Lido House Hotel Environmental Impact Report

FINAL ENVIRONMENTAL IMPACT REPORT

LIDO HOUSE HOTEL

2.0 RESPONSE TO COMMENTS

ATTACHMENT A

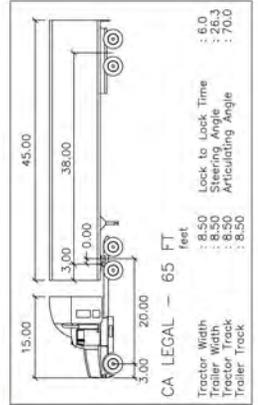
It is not practicable to modify the Finley or Via Lido entrances so that they could accommodate large vehicle access. Even if it were possible, such modifications would be extensive and expensive, and would likely require removing a substantial number of parking stalls. This would result in insufficient parking spaces for the Via Lido Property to meet City requirements. Routing deliveries or emergency services through the Finley entrance would also have the potential to seriously disrupt pedestrian traffic

The City acknowledges that closure of the driveway will require that the operations at Via Lido Plaza facilitate delivery traffic at either of the other two driveways. The turning radius graphic included with the comment letter as Attachment A does show the difficulty of the largest delivery truck attempting to make a right turn from the #2 lane of eastbound Via Lido without using the entire driveway on Via Lido Plaza. In reviewing the access exhibit provided in Attachment A of the comment letter, the City acknowledges that access for the largest delivery truck from Newport Boulevard/Finley Avenue through the existing parking lot entry may not be feasible due to the design features installed by the owners of Via Lido Plaza. However, these design features do not preclude access by trucks that are smaller and more maneuverable. The City concurs that egress from the truck dock on the Via Lido property to Via Lido is viable, as shown in the upper middle view of the same referenced exhibit. However, the City respectfully takes exception to the entry analysis from Via Lido as shown on the truck turn study provided in Attachment A of the comment letter. The exhibit assumes a vehicle is present in the northbound exit lane of the Via Lido Plaza driveway, thereby restricting access. While a vehicle in this position would restrict access, the same condition exists while entering from 32nd Street to the existing driveway (refer to Exhibit 1, Existing Conditions, which was prepared by Fuscoe Engineering and is included in

Attachment 1 of this response³). If the assumption is that vehicles are in fact in this position, access to the Via Lido Plaza from both streets is not feasible even in the existing condition. This assumption is speculative and unrealistic. The comments to the Draft EIR also imply that current access is taken from the existing gated vehicular access location leading to a driveway across the project site to 32nd Street. Both the truck turn study provided in Attachment A of the comments letter, as well as the Exhibits in the Fuscoe Engineering study (refer to Attachment 1 of this response), show that the truck envelopes encroach into the adjacent, opposing lane when entering from either Via Lido or 32nd Street. Fuscoe Engineering found no scenario where encroachment into the opposing lane would not occur in either the existing or proposed conditions, from either street. A more practical scenario is that there is no vehicle in the opposing lane, or if there is, a delivery truck would wait until the vehicle cleared the lane.

Entry access from Via Lido also appears to be an easier maneuver than using the 32nd Street driveway entry as it requires only a single backing maneuver (refer to [Exhibit 2A](#), [Ingress](#), which is included in Attachment 1 of this response) while the 32nd Street entry indicates a three point turn is required for access to the truck dock. As an alternate access scenario, Fuscoe Engineering also routed a truck from eastbound 32nd Street, north onto Lafayette Road and northwest onto Via Lido (refer to [Exhibit 2B](#), [Ingress](#), which is included in Attachment 1 of this response). This path provides access to the Via Lido property from the westbound left lane of Via Lido, avoiding entering Via Lido from Newport Boulevard. Access to the truck dock facility located in Via Lido Plaza is viable from Via Lido from either direction, and would provide easier truck movement on the Via Lido property than is possible by using the 32nd Street driveway as Fuscoe Engineering's analysis indicates that truck traffic can readily enter from Via Lido without interference. It should also be noted that scuff marks on the existing curb returns indicate that vehicle tires have rubbed the curb face in the past. If upon final design the City considers it necessary to address this minor access limitation from Via Lido, the existing driveway approach curb aprons would be improved to accommodate a larger radius using current City of Newport Beach standards as guidelines to provide additional room for maneuvering.
